PATTERSON CROSSING RETAIL CENTER
FINAL ENVIRONMENTAL IMPACT STATEMENT

Lead Agency Acceptance Date: June 12, 2008

PATTERSON CROSSING RETAIL CENTER
Final Environmental Impact Statement

**Figure 2-1: Lake Carmel Park District
Patterson Crossing Retail Center
Town of Patterson & Town of Kent, Putnam County, New York**
Source: Putnam County Real Property Data
Scale: 1" = 1,600'

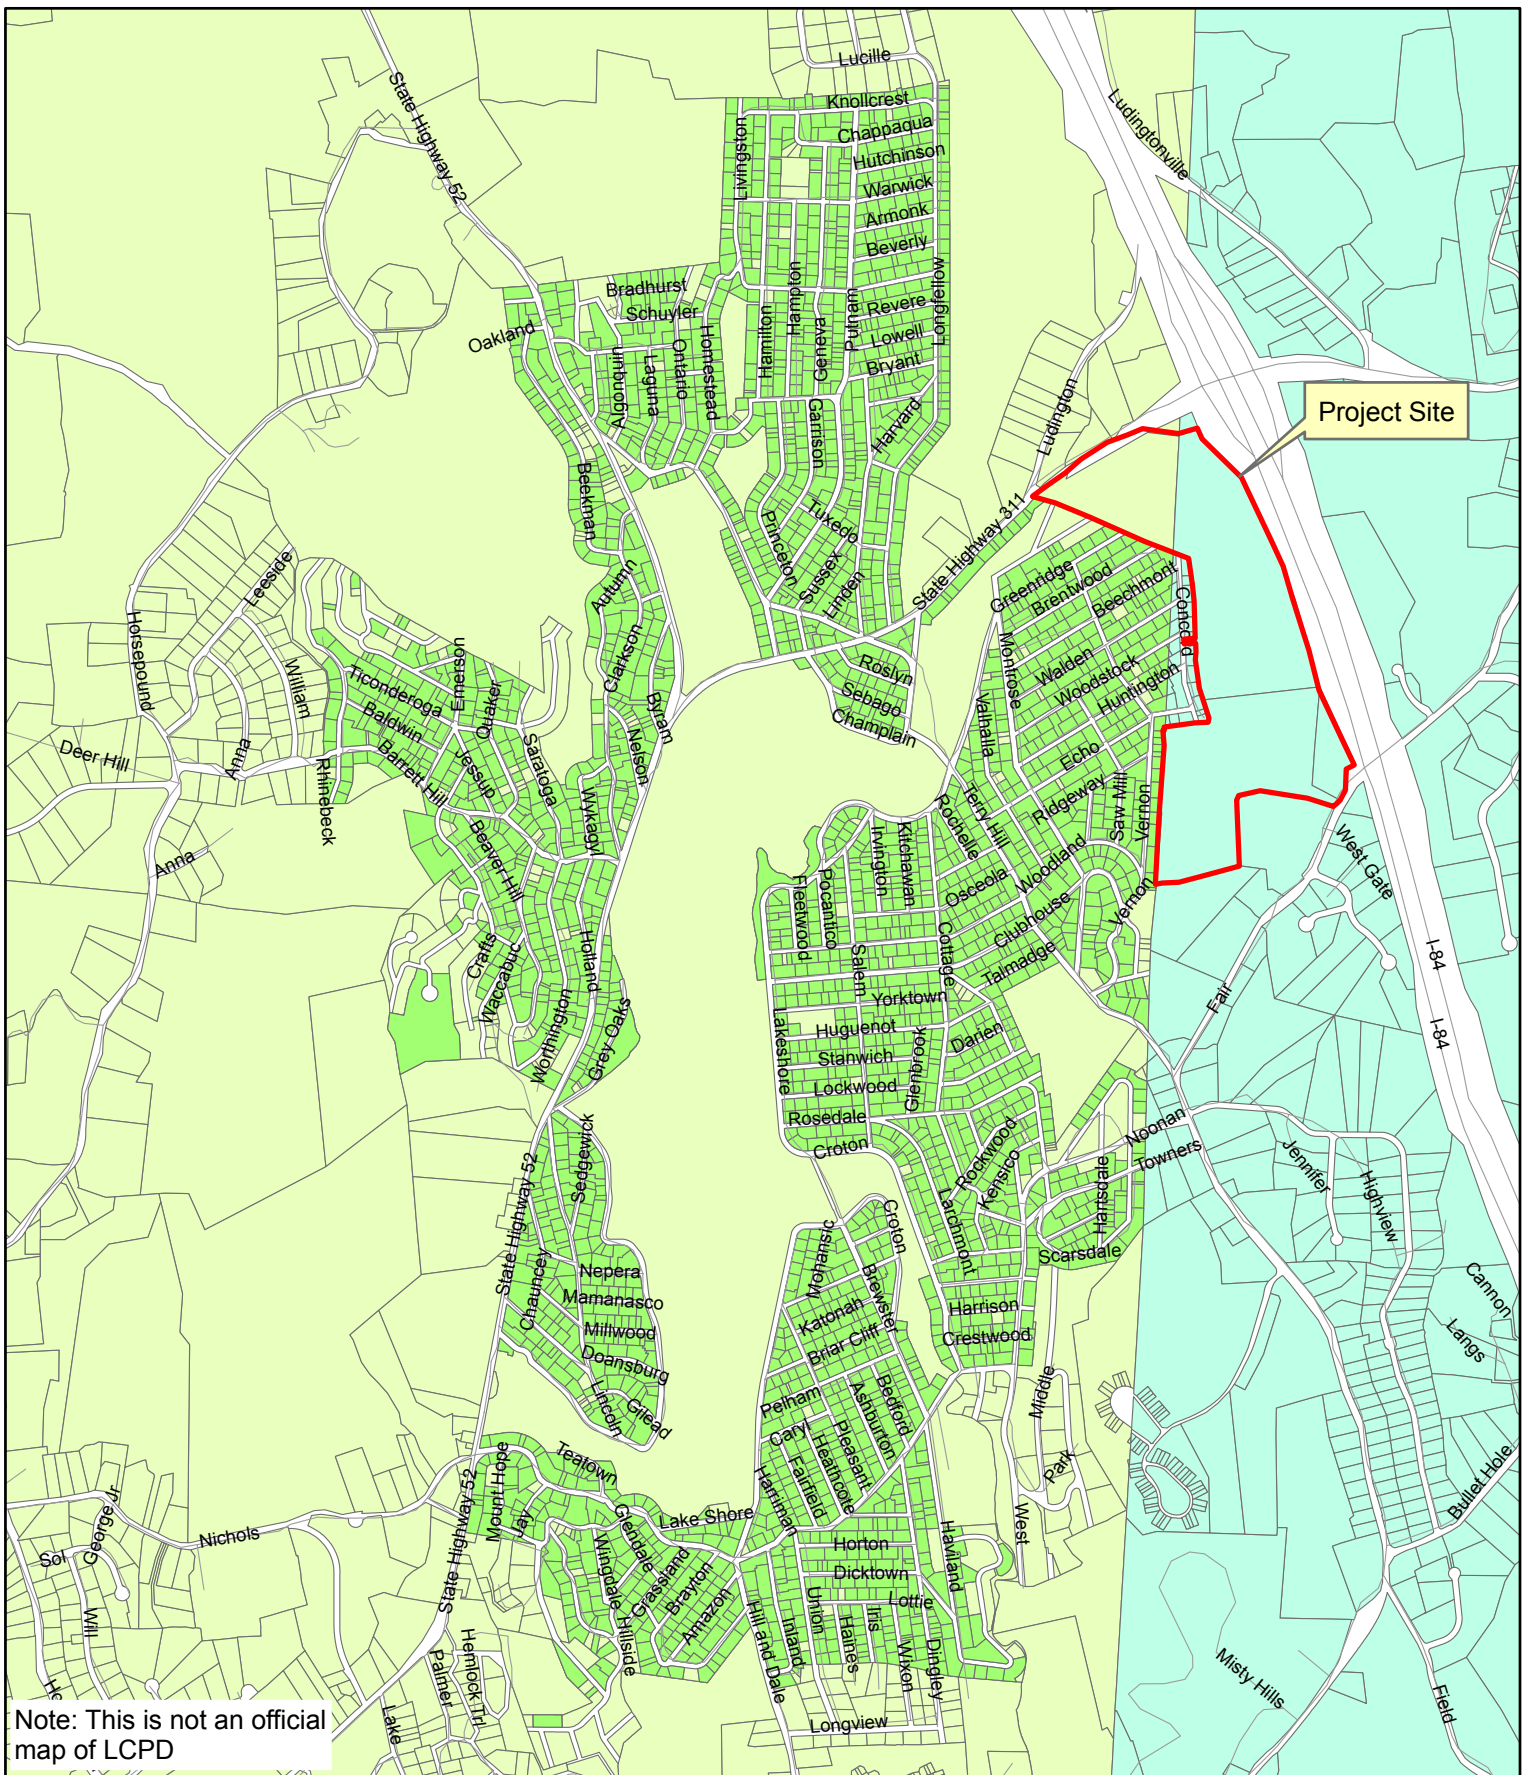
Comment 2.1-8 (Letter #C4, Elena Bao, 09/25/06): Figure 2-1 does not adequately illustrate the "Regional & Local Setting". The Applicant should also include a map which clearly illustrates the boundaries of the Lake Carmel Park District with an overlay of the project site (this map can be obtained at Kent Town Hall). The Lake Carmel Park District map is critical in assessing the impacts of the Patterson Crossing project on the park district. The Applicant was highly remiss in failing to make even one reference to the existence of the Lake Carmel Park District in this DEIS. This legal entity exists, and the Applicant must acknowledge the park district's existence. Further, this DEIS needs to discuss in detail the statutory definition of "park district" and also include the "legal purpose" per the statutes for the creation of a park district. This project's impacts MUST be analyzed within the particular context of the park district and that district's whole purpose for existing because the project itself abuts the park district. The dominant regional characteristic of the surrounding residential community is that of a "park district". This needs to be addressed in the DEIS.

The Applicant contacted Kent Town Hall (Town Clerk and Assessor's offices) and Putnam County Real Property Services, however no map defining the legal boundaries of the Lake Carmel Park District was available or known to exist. FEIS Figure 2-1 shows the project site on a map of the parcels located in the Lake Carmel Park District based on data provided by the office of Putnam County Real Property Services.²

² The perimeter outline of the mapped parcels in FEIS Figure 2-1 generally coincides with the hand drawn boundary of the District on an undated map entitled "Lake Carmel", with a street key entitled "Lake Carmel Property Owners Association", that was provided to the Applicant by the Town of Kent. Neither the map provided by the Town nor FEIS Figure 2-1 are considered "official" maps of the legal boundaries of the Lake Carmel Park District.

Figure 4.1-1: Rock Removal Plan
 Patterson Crossing Retail Center
 Town of Patterson and Town of Kent,
 Putnam County, New York

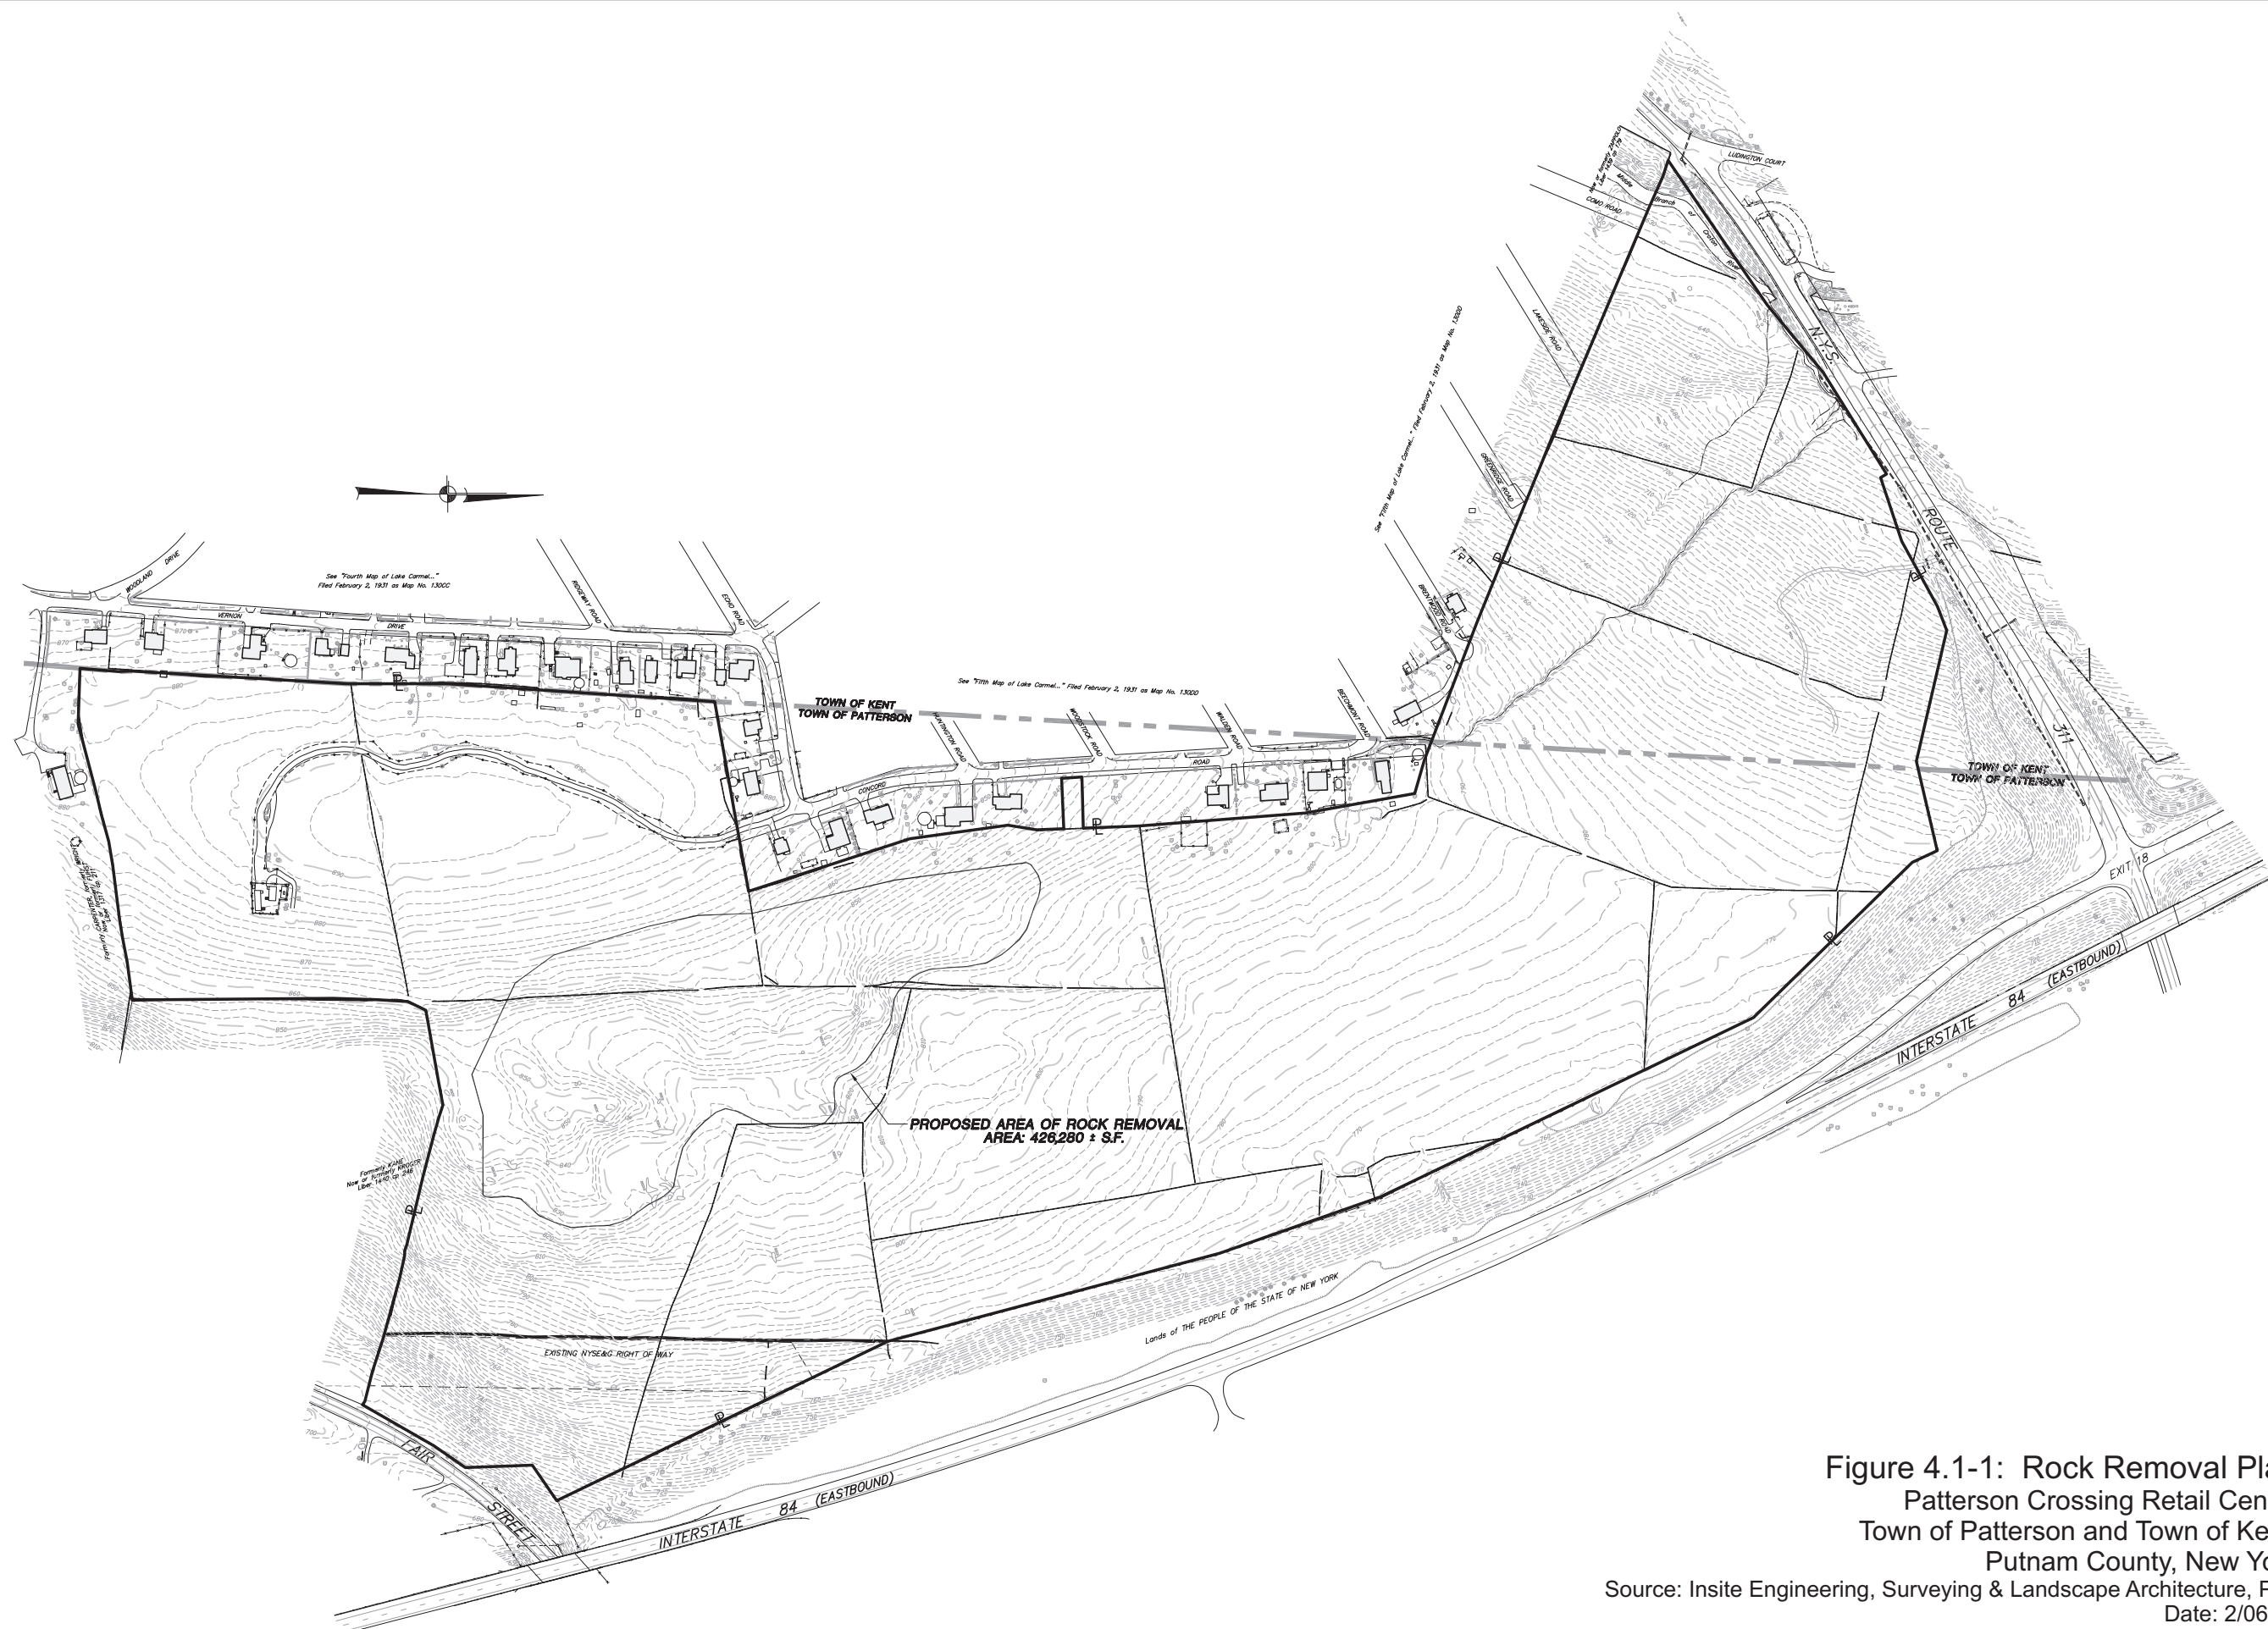
Comment 4.3-4 (Letter C-23 Daniel Kuchta, September 25, 2006): Figures 4.3-3 and 4.3-4 show that the emergency access road location includes a slope that is 25%+. Figure 4.1-1 shows the area of rock removal which does not appear to enclose the portion of the steep 25% slope that the emergency access road goes over. Will the emergency access road include a steep slope?

Response 4.1-1: *The area of potential rock removal was depicted on DEIS Figure 4.1-1. This figure shows an area that extends from the south-central portion of the site north towards the western boundary. As stated in the DEIS on Page 4.1-1: “Bedrock at the surface occurs in several locations on the site, primarily in the south central section of the property.” No rock removal is anticipated in the area formerly proposed for the development of Buildings F through I.*

The DEIS states on page 4.1-2 that 119,000 cubic yards of rock would need to be removed. The site plan has been revised since that time and the building pad elevations have been raised to better balance the earthwork. As a result, the amount of rock removal has been reduced by approximately 50 percent from that presented in the DEIS. The area within which rock removal would potentially be required under the plan presented in the DEIS was limited to approximately 11 acres. This area has been reduced under the modified plan to approximately 9.8 acres and is depicted on Figure 4.1-1 herein. Refer also to Response 1.3-23.

**Figure 4.5-1: Middle Branch Watershed
Patterson Crossing Retail Center
Town of Patterson and Town of Kent,
Putnam County, New York**

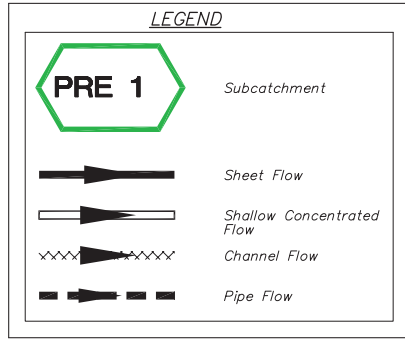
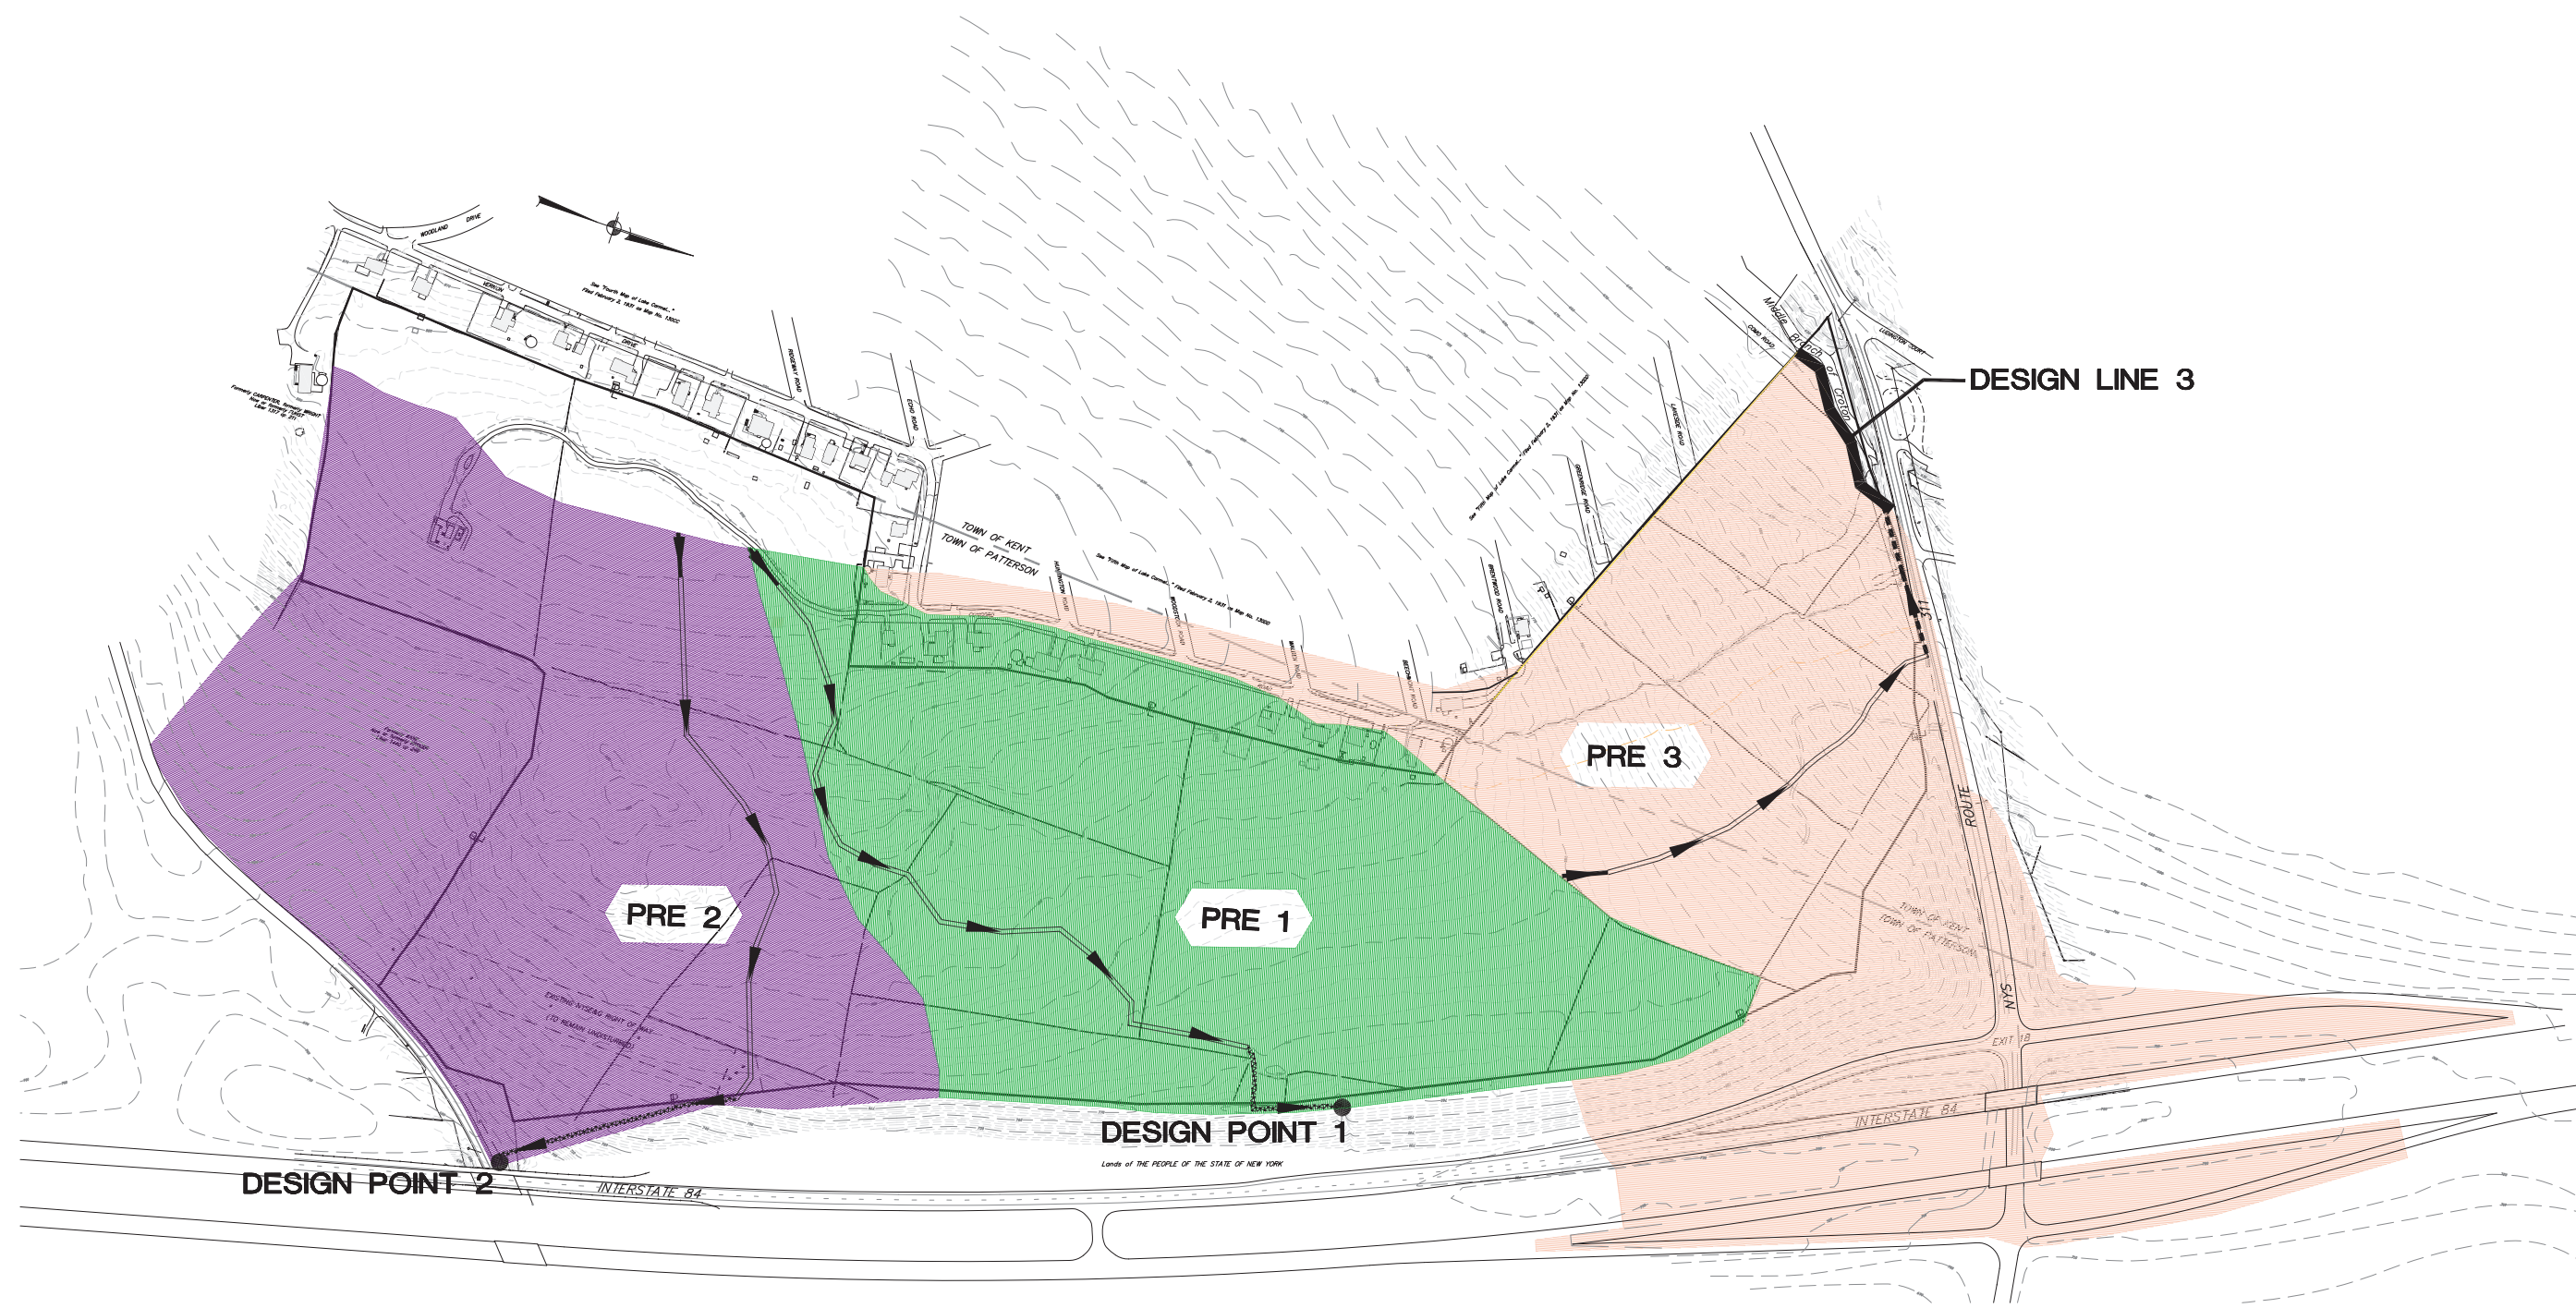
Comment 4.5-20 (Letter A-8 Michael W. Soyka, P.E., September 8, 2006): Refer to the last paragraph on page 4.5-5. The monitoring site on the Middle Branch of the Croton River is shown as “MIDBR8” on this page and “MIDBR4” on Figure 4.5-1.

Response 4.5-20: *MIDBR8 is the correct designation for the NYCDEP monitoring site that is discussed on Page 4.5-5 of the DEIS. DEIS Figure 4.5-1 has been revised to indicate MDBR8 and is included in this FEIS as Figure 4.5-1.*
